**DA NO:** DA-2021/27/C

**ADDRESS:** 16 & 18 WARNERS AVENUE, WILLOUGHBY NSW 2068.

**PROPOSAL:** MODIFY ORIGINAL PROPOSAL TO INCLUDE LIFT LOCATION AND DETAILS, CHANGES TO LANDSCAPING, FAÇADE AND WINDOWS OF TOWNHOUSE 1, REVISED TANK DESIGN AND ASSOCIATED WORKS.

Figure 4: Proposed western elevation showing lift location and glazing amendments.

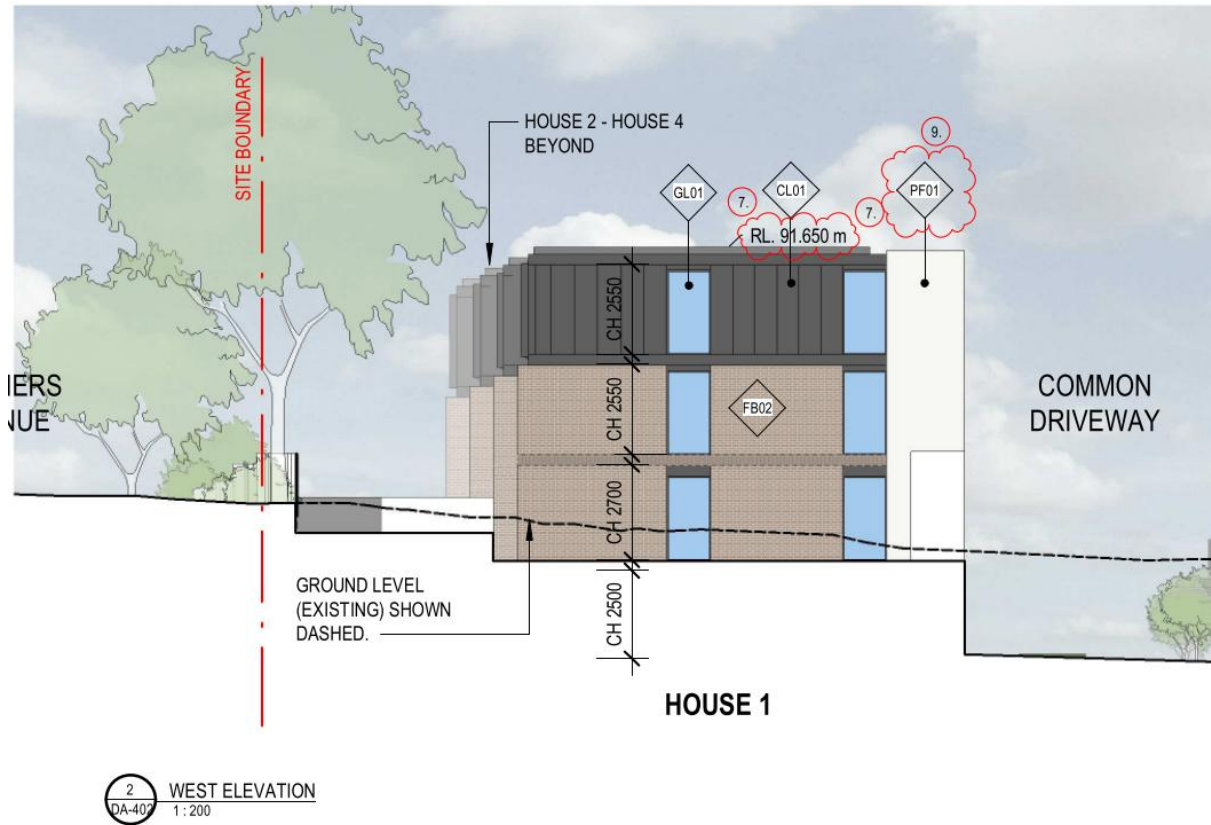
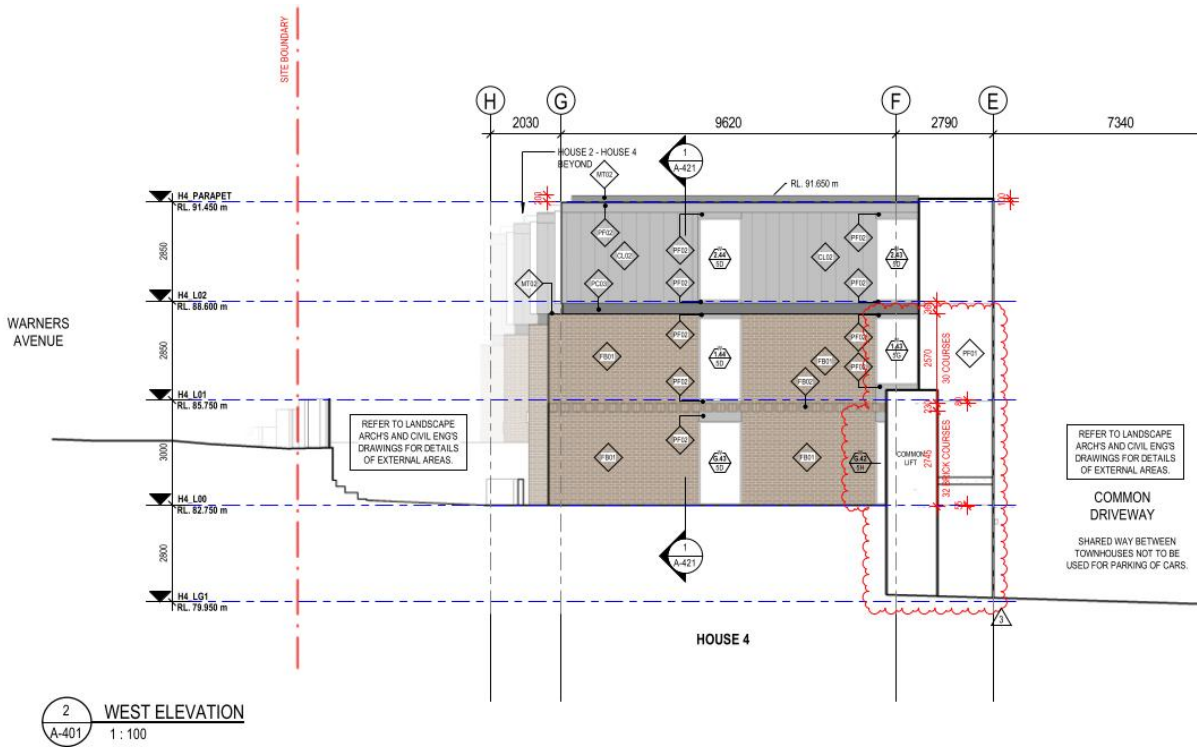
- **Amendments to House 4 western elevation with regards to windows.**

<p><b>Facade changes</b></p>	
<p>“Facade changes are not defined or sufficiently detailed”</p>	<p>The proposed facade amendments are minor and limited to proposed house 4 where the lift shaft requires window amendment.</p>
<p><b>Plans showing internal floor changes</b></p>	
<p>“We note that the plans submitted with this modification application (General Arrangement Plan First Floor A-102 Rev 5 dated 11.08.22) shows Townhouse 7 has reverted to a bedroom on the top floor instead of the approved living space, which means that Townhouse 7 will not achieve the minimum solar access to a living space.”</p>	<p>No approval is given for changes to bedroom numbers from the parent approval. The modification only seeks the amendments as listed in this report and within the supplied SEE. In addition, the plan that shows the bed as mentioned does not form part of the modified plan set, ensuring the original design/arrangement remains.</p>

Figure 6: Proposed OSD.

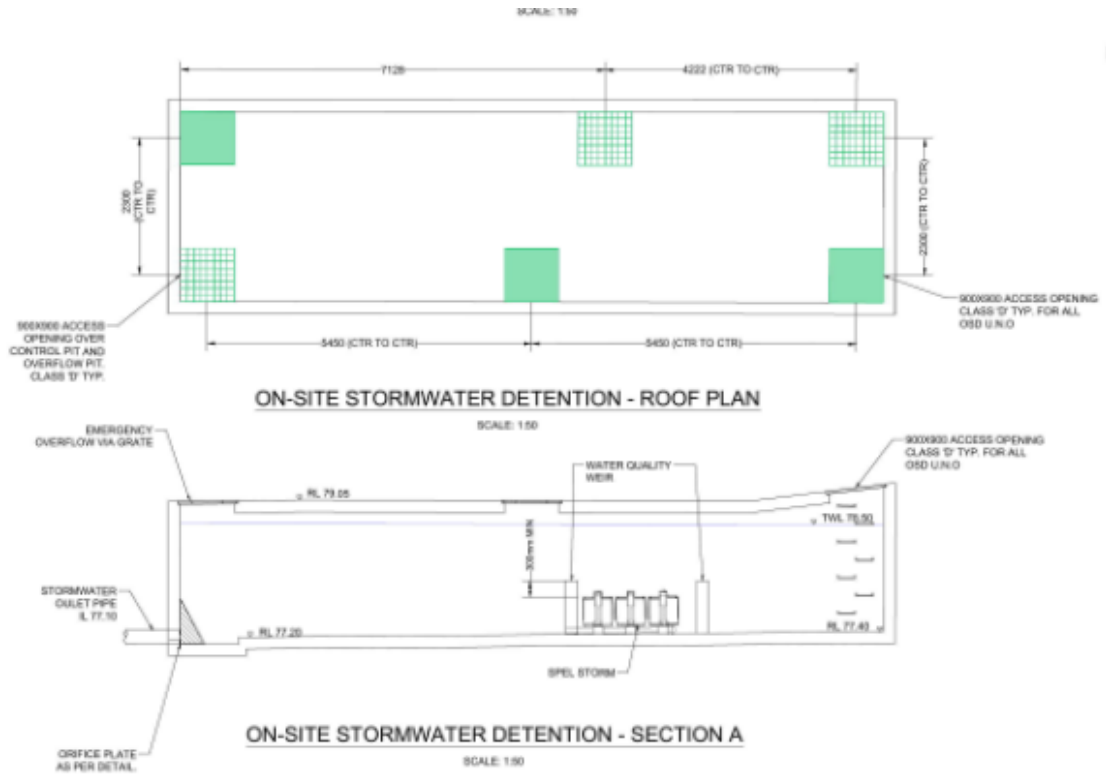
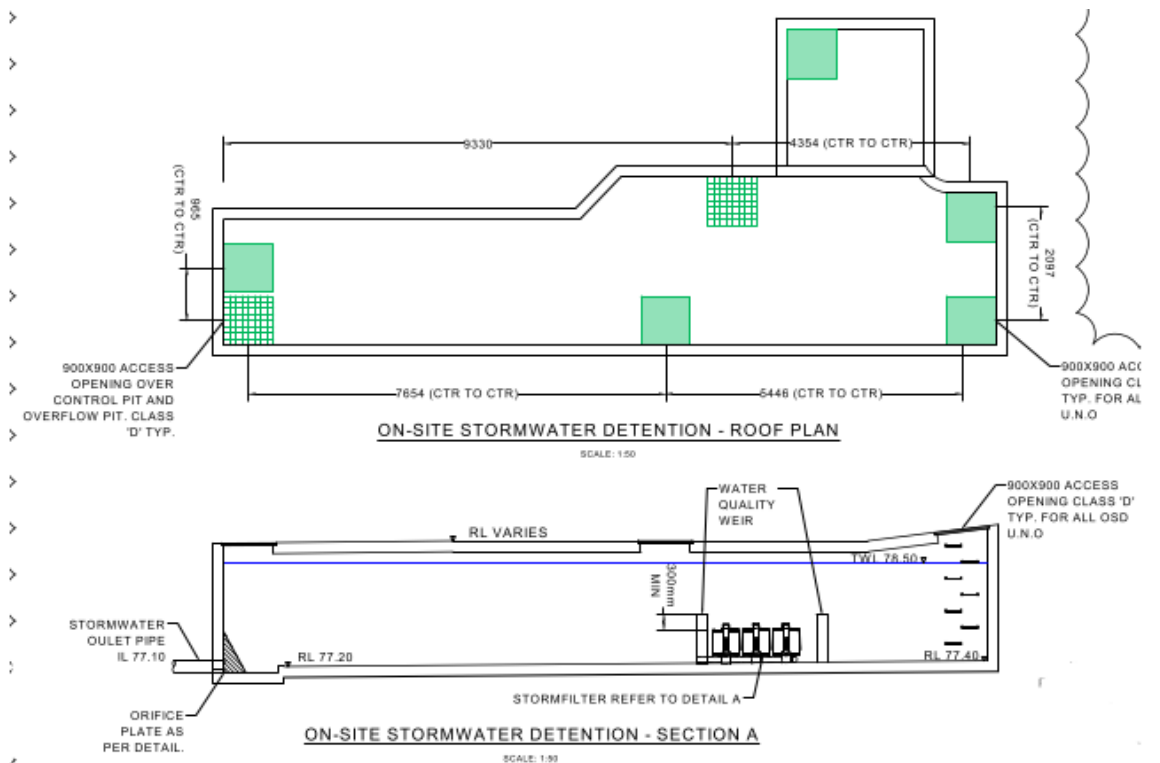
- **OSD Tank redesign**

“very concerning that the developer would submit plans to build and extend the underground water tank right beside a neighbouring property without providing any plans or information on how this might impact on the neighbour’s property.”	
“The applicant has also not provided critical information for the assessment of the modified OSD design, including a plan showing structures within the zone of influence on the neighbouring property, a geotechnical report, or a construction methodology report”

- a) Geotechnical Engineer's report regarding the stability of the proposed OSD system. The report is to include excavation methodology, the nature and type of any temporary shoring, and how geotechnical risks to 14 Warners Ave will be appropriately mitigated and managed.
  - b) Certification from a suitably qualified Structural Engineer, typically CPEng, that the design complies with the relevant standards.
- (Reason: Structural Adequacy)
